**SAN ANTONIO WATER SYSTEM  
SAWS Production Facility Fence Replacement Project  
SAWS Job No. 14-0117  
Solicitation No. B-14-041-DB**

**ADDENDUM NO. I**

**September 23, 2014**

**LOCK ASSEMBLY**

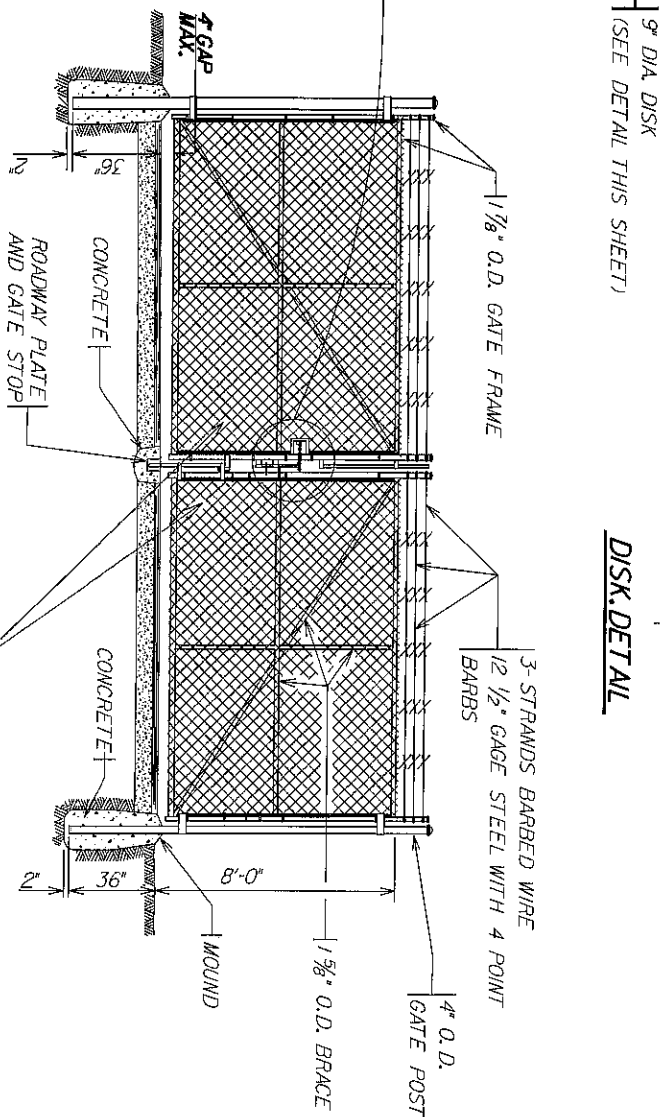
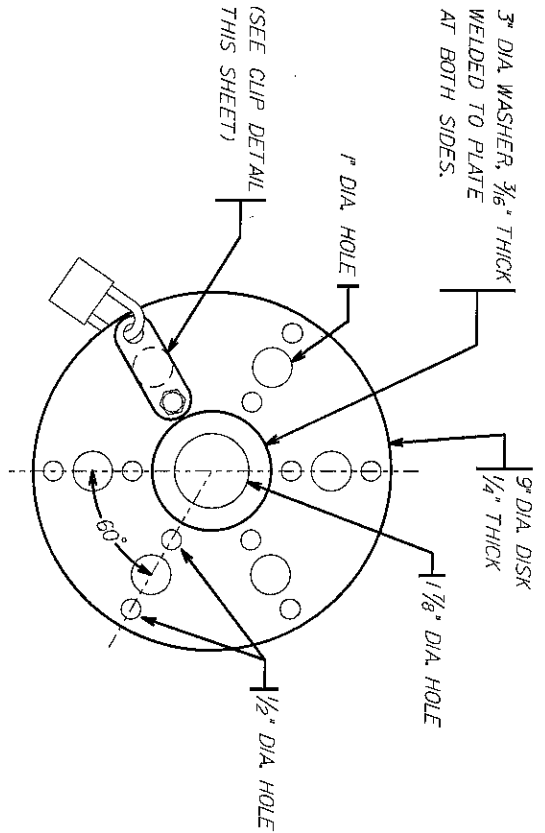
**Q: On the Lockhill and Inwood sites the gate have the old wheel type multiple locking design. Will this feature be necessary in new fabrication, if so, please supply design for that purpose.**

A: Yes, See Attached Exhibit E
